SERVICE BULLETIN NO. 29.

SUBJECT: Revised gust locks. Mod. No. B83.

EQUIPMENT AFFECTED: Airtourer 100 & 115 (all aircraft).

VIEW ON LHS OF REAR FUSELAGE AT APPROX STN SHOWING INSTALLATION OF SCOOP OVER FUEL TANK VENT

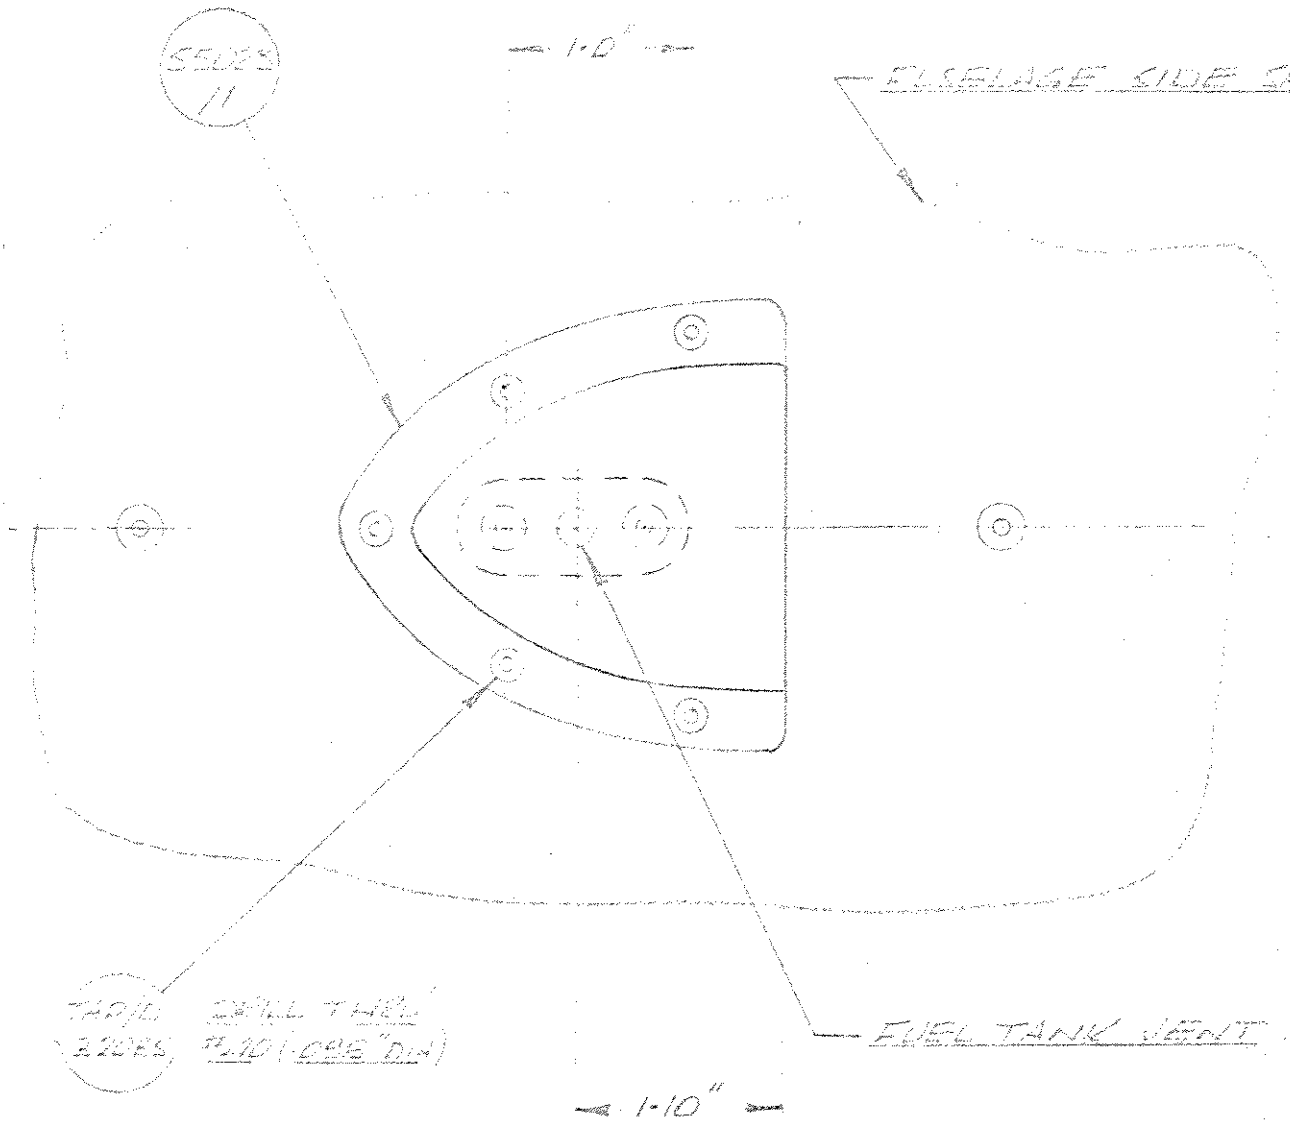
SERVICE BULLETIN NO. 23

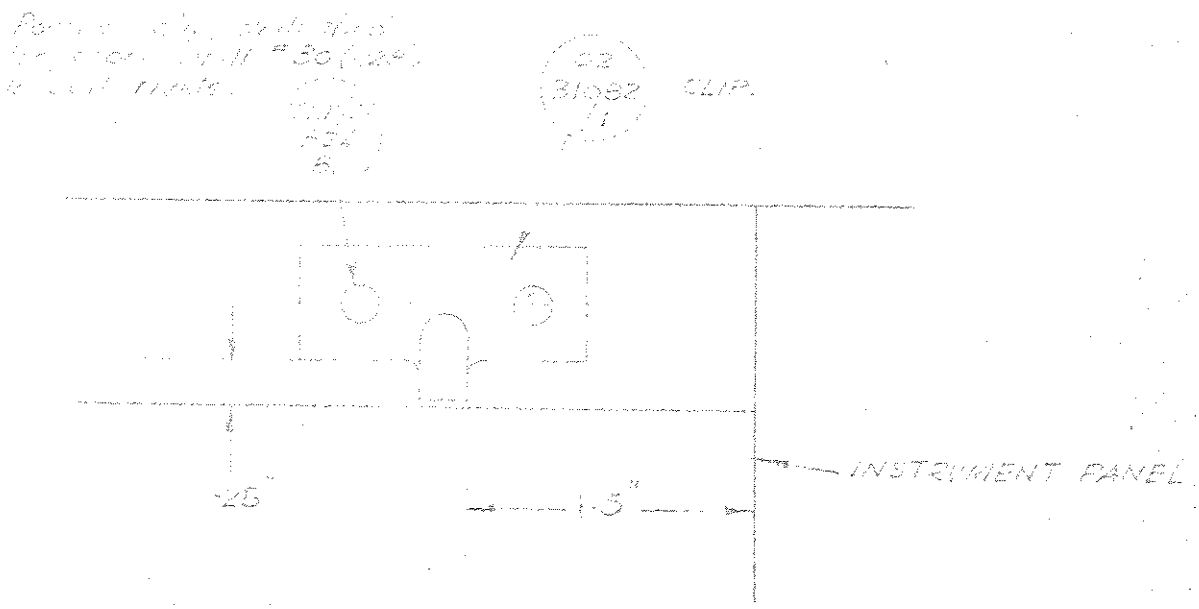
PURPOSE: Improved design to ensure security of outer ends of gust lock.

REASON: To prevent outer ends of gust lock springing from location holes and causing possible injury to occupants.

DETAILS: Attach clips (Part No. 02-31082) to port and starboard upper longeron as shown below:

SERVICE BULLETIN NO. 30

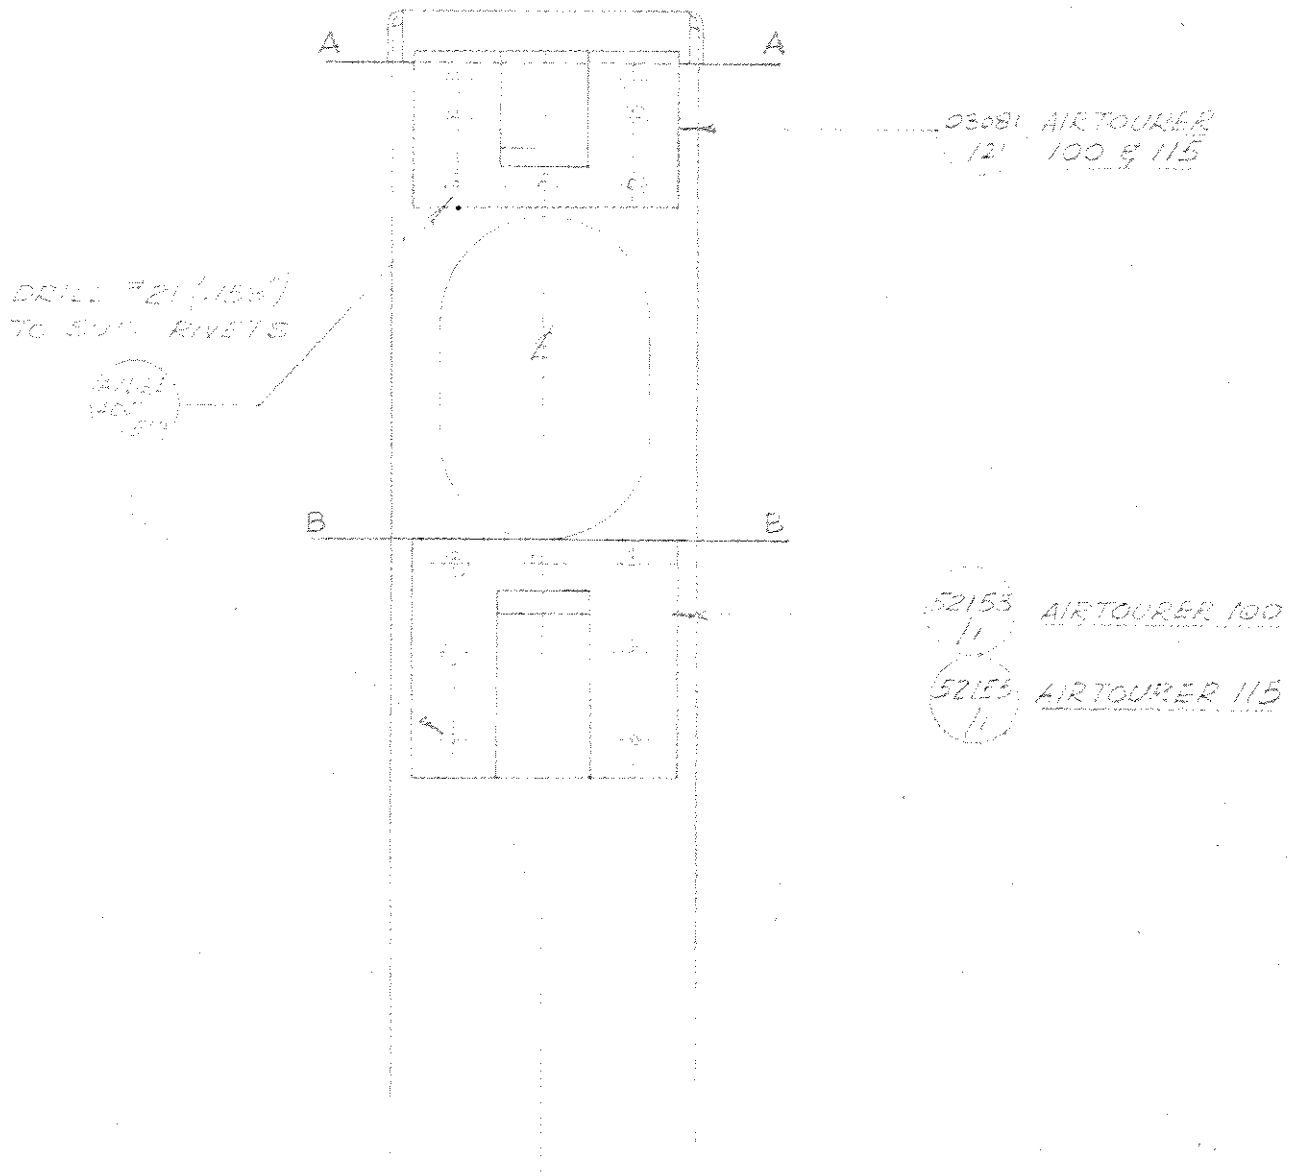
SUBJECT: Elevator stop brackets on control column torque shaft. Mod.No.B.

PURPOSE: Redesigned to give positive up and down stops to elevator contro

REASON: Stops were found to be bending in service.

(c) Check new brackets (for correct application) with drawing.

(d) With the forward stop bracket in line with the rear edge of the front flange of the torque shaft, line A-A, match up the centre lines of the respective parts. Drill through from bracket into torque shaft with Drill No. 21 (.159") and rivet in position using "AVDEL" 402/510 rivets.

(e) Repeat for rear stop bracket in conjunction with rear edge of cut out, line B-B.

(f) Use retained stop bolts Pt. Nos. 52034 and 52135 in rear and forward stop brackets respectively.

SECTION THRU FUEL FILLER CAP

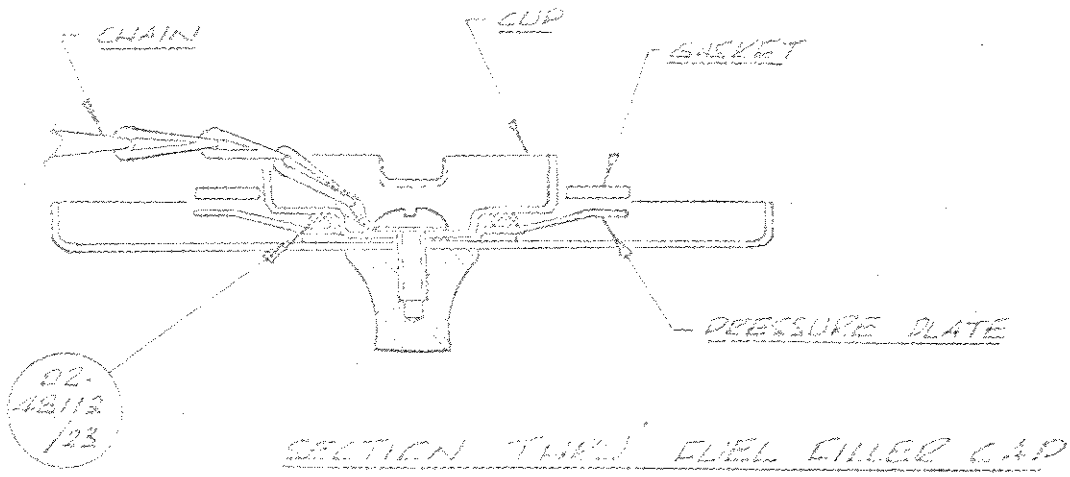
SUBJECT: Introduction of 'O' ring in fuel cap. Mod. B.100.

PURPOSE: To ensure sealing of the fuel cap.

REASON: Service experience has shown that fuel stains progress back from the filler cap along the fuselage side. Investigation has shown that the leak is from behind the gasket pressure plate.

(b) Wet 'O' ring with mineral hydraulic oil and stretch over centre cup of cap. Using thin blunt edge, push 'O' ring between cup and pressure plate as shown.

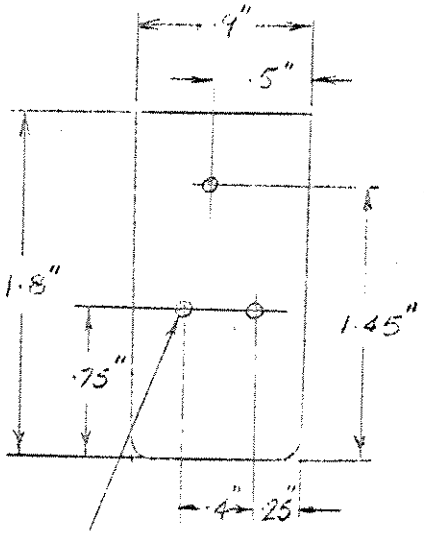
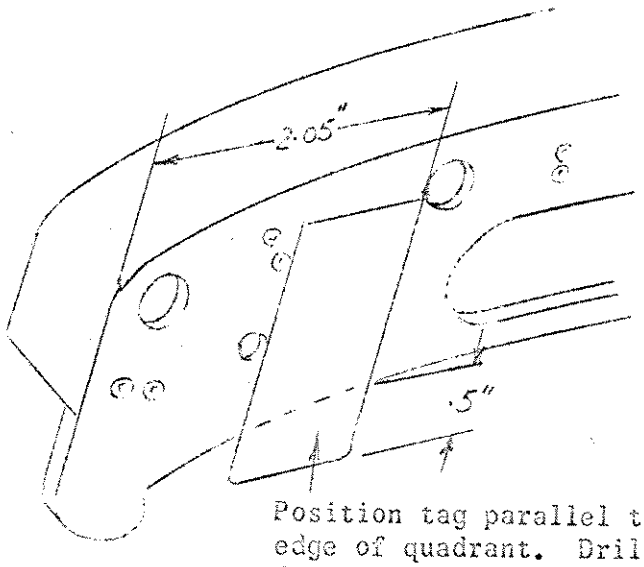
SUBJECT: Limitation of Flap Movement Mod. B.129

DETAILS: Due to unfavourable flying characteristics with flaps fully down it is necessary to restrict the full flap down movement to 3/4 flap (3 notches).

To prevent any further use of the 4th notch of flap, a light alloy, 16 S.W.G. stop tag should be rivetted to flap quadrant as shown below.

3 holes, No. 30 (.128") to suit rivets

Position tag parallel to rear edge of quadrant. Drill through from tag and rivet using Tucker 'Pop' rivets TLP/D 435 BS.

FIG 1

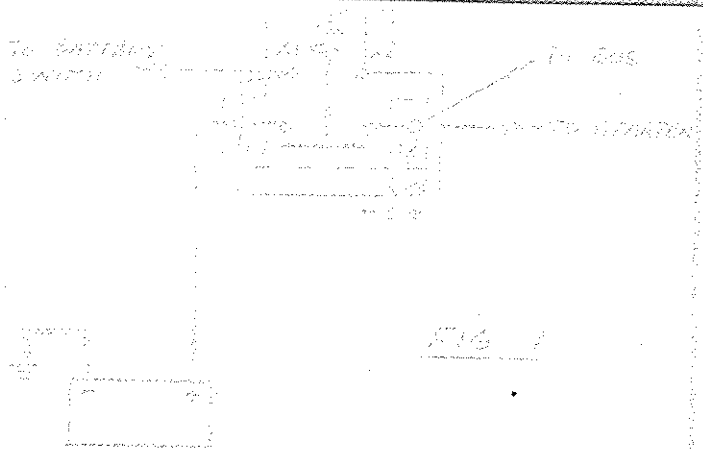
SUBJECT: BATTERY RELAY, PART NO. REL 1 - 2. (MOD. B 167)

PURPOSE: To reverse battery relay mounting.

REASON: Service experience has shown that the present mounting position does not allow condensed moisture to drain from the unit. The resulting corrosion may cause an open circuit in the solenoid coil.

AIRTOURER 100 ONLY - Replace the relay on to the firewall with the solenoid coil uppermost. Secure, using original bolts, washers and nutplates. Reconnect cables, jumper and diode in accordance with figure 1.
